City of HOBART

APPLICATION UNDER SULLIVANS COVE PLANNING SCHEME 1997

Type of Report: Committee
Council: 17 September 2018
Expiry Date: 4 March 2019
Application No: PLN-17-1041
Address: 106 SALAMANCA PLACE , BATTERY POINT
Applicant: Aurora Clarke
106 Salamanca Place
Paul Thompson
106 Salamanca Place
Proposal: Partial Demolition, Alterations and Multiple Dwelling
Representations: Twelve
Performance criteria: Heritage and Demolition

Figure 6: Southern elevation of the proposal

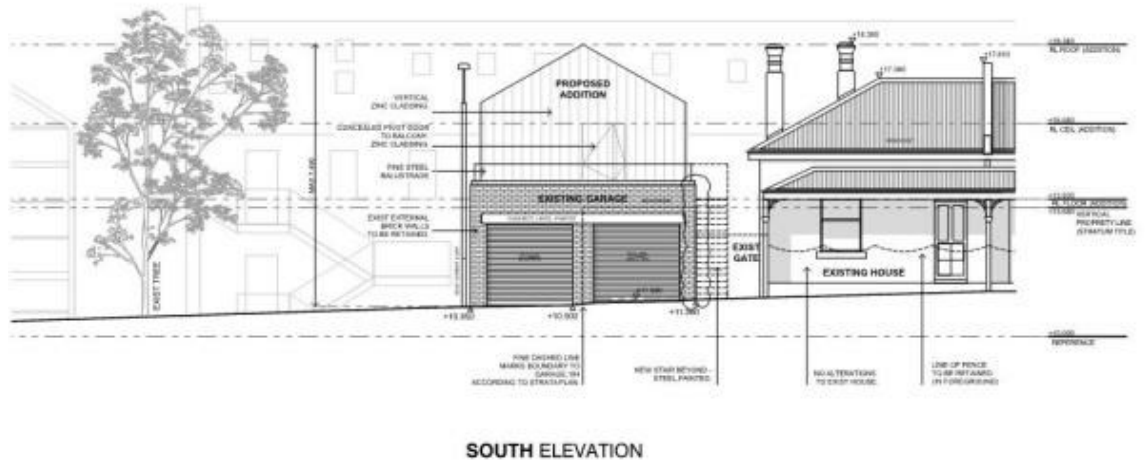
From the submitted plans, elevations and photomontages submitted in support of the proposal, it is clear that the development would significantly increase the height and overall bulk of the existing flat roofed garage, effectively creating a two storey structure within a row of single storey cottages. The proposed extension would be visible from Princes Park, and from the roadside, both in the immediate and from longer views. As part of the supporting documentation submitted with the application, a Heritage Impact Statement and a separate Design statement has been prepared by Paul Davies Pty Ltd. Mr Davies does not directly address the issue of prominence, but rather makes comments on the issue of dominance in relation to views in which the cottage is experienced.

Taking the above, it is considered that the proposed extension, by virtue of its height, bulk and location in relation to the cottage and the wider row visually would be the principal feature seen when approaching along Salamanca Place and would clearly therefore meet the definition of being prominent and noticeable. Whilst adopting a form that is recognisably new, it is considered that the proposal would fail to fully meet this criteria

With regard to the above, it is noted that the proposed extension has adopted a largely featureless design with hidden eaves, notable lack of fenestration to front facing gable and utilisation of cladding more commonly associated with industrial roofing. In colouration, the proposal has adopted a dark colour to largely match that of the roof of the cottage and the rest of the row in which it stands. It would therefore largely read as a stylised 'industrial' gable roof structure partially viewed against the roof planes of the cottages.

Whilst it is acknowledged that the existing garage was an unfortunate addition during the life of the cottage, it does retain a degree of subservience to the cottage. In contrast, the proposal would substantial add to its height and bulk, with the overall height and eaves line notably exceeding that of the cottage, (not correctly shown on the photomontage which shows the height of the structure at a lower level). In so doing, it would become the highest structure within an otherwise balanced group which in part derives its collective strength from its uniformity of scale.

When viewed from the west, due to its height and bulk, it would obscure large parts of the cottages return elevation, its roof form and chimneys, as well as those of the row beyond, removing the ability to understand and read the dimensions of the cottage. The design and proposed cladding hints at a semi-industrial architectural expression that whilst echoing limited elements of the working port of the Cove, would sit uncomfortably within what is a clearly residential enclave.

1. The proposed development would fail to complement and contribute to the cultural significance, character and appearance of this place of cultural significance or its setting contrary to 22.4.5 of the Sullivans Cove Planning Scheme 1997.
2. The proposed development, by virtue of its location, bulk, height and form would be individually prominent to this place of cultural significance and its setting contrary to 22.4.5 of the Sullivans Cove Planning Scheme 1997.
3. The proposed development, by virtue of its location, bulk and appearance would adversely affect the heritage values of this place of cultural significance, its setting and those of the cottages which make up the wider row, contrary to 22.4.5 of the Sullivans Cove Planning Scheme 1997.
